645-017-11

ADDENDUM NO. 2

Wayne State College
Carhart Building Phase III
Wayne, NE
TCEP No.: 645-017-11

Addendum #2
 Supplemental Drawing: SDM-010
 Revision of Sheet: M2.4
 Date: April 10, 2012

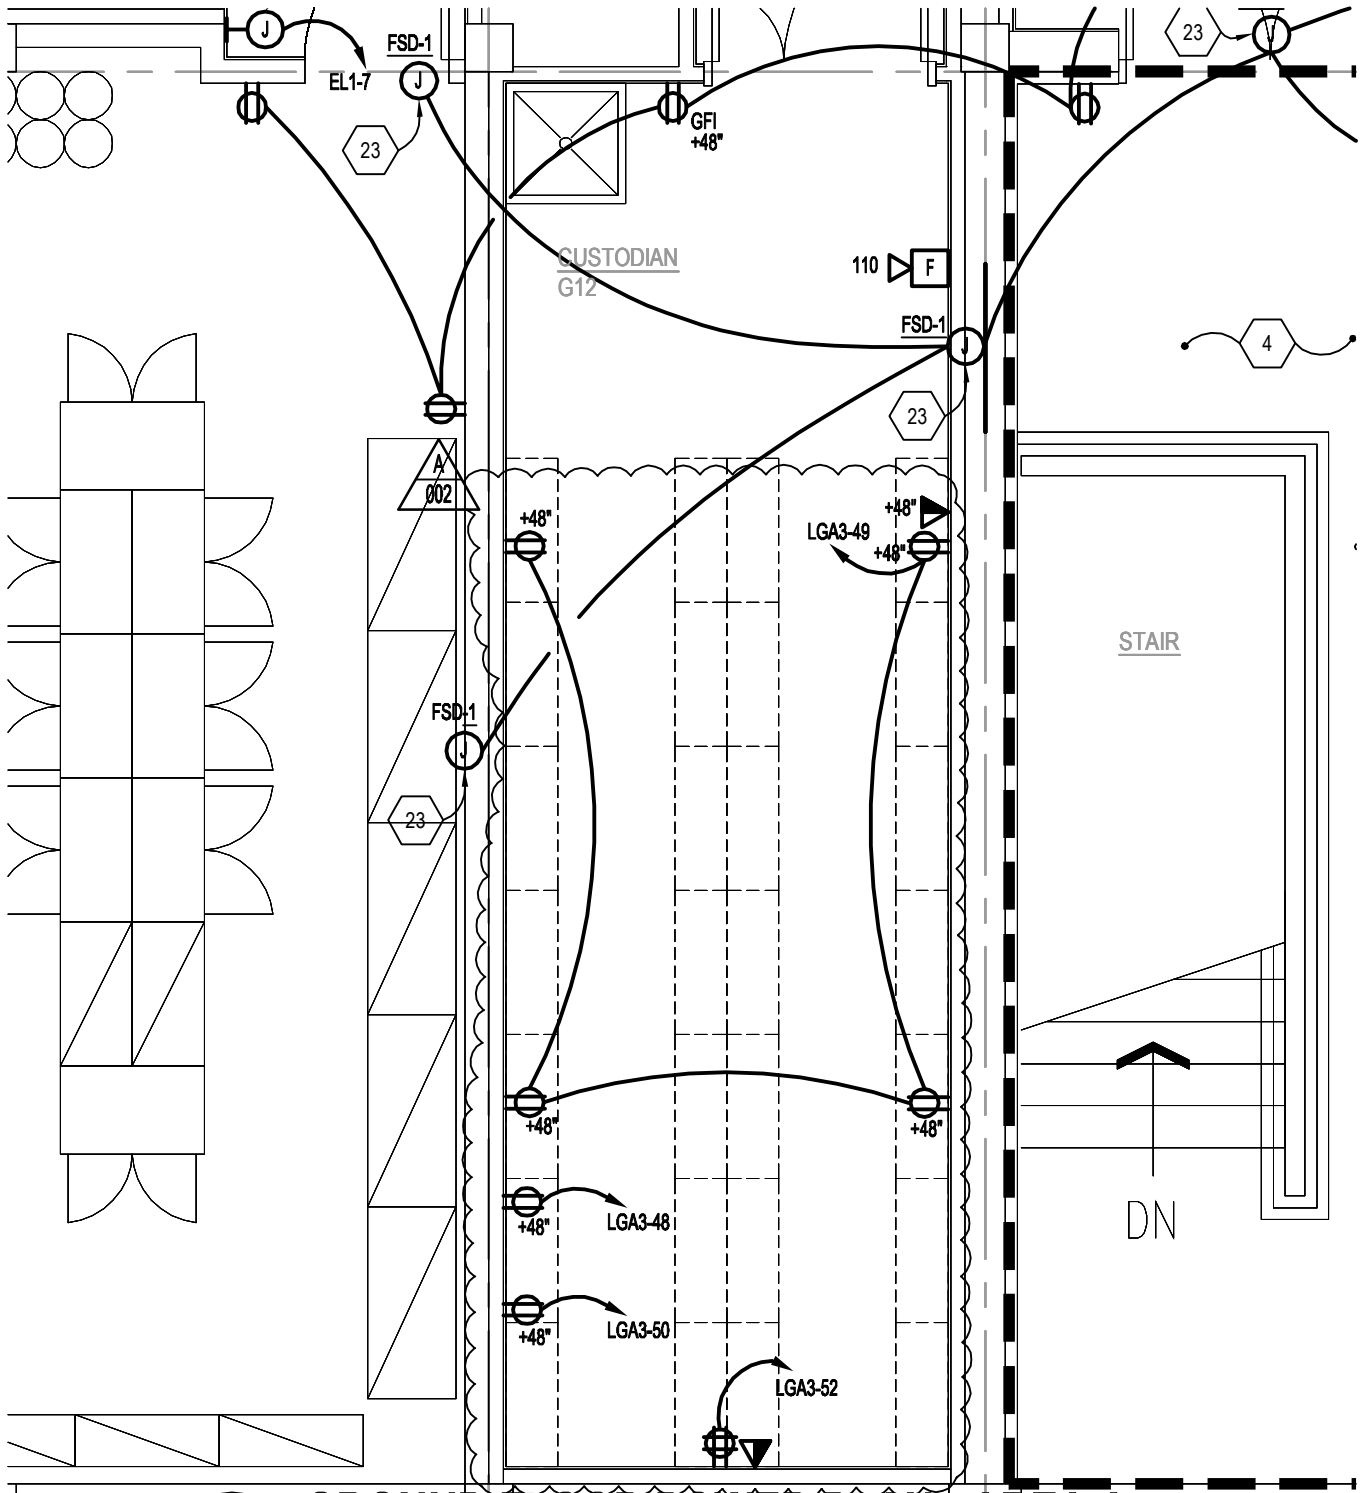
Provide TD-1 with 3" trap with 2" VUF and 1 ½" AV up to new 2" AV as shown on SDM-010.

Reroute the existing 2" fire sprinkler test/drain from existing isolation valve sloped to gravity drain out through exterior wall and terminate above new area drain basin grate as shown on SDM-010. Infill demolished piping opening through wall and provide Link Seal Model LS at new core drilled piping penetrations through exterior wall above new area drain.

Reroute the existing 2" sump pump discharge from the existing sump pump discharge drain piping out through exterior wall and terminate above new area drain basin grate as shown on SDM-010. Infill demolished piping opening through wall and provide Link Seal Model LS at new core drilled piping penetrations through exterior wall above new area drain.

Provide additional lateral braces, hangers and/or supports as necessary to rigidly support and anchor the existing 3" PVC waste stack in chase through First and Ground levels as noted on SDM-010.
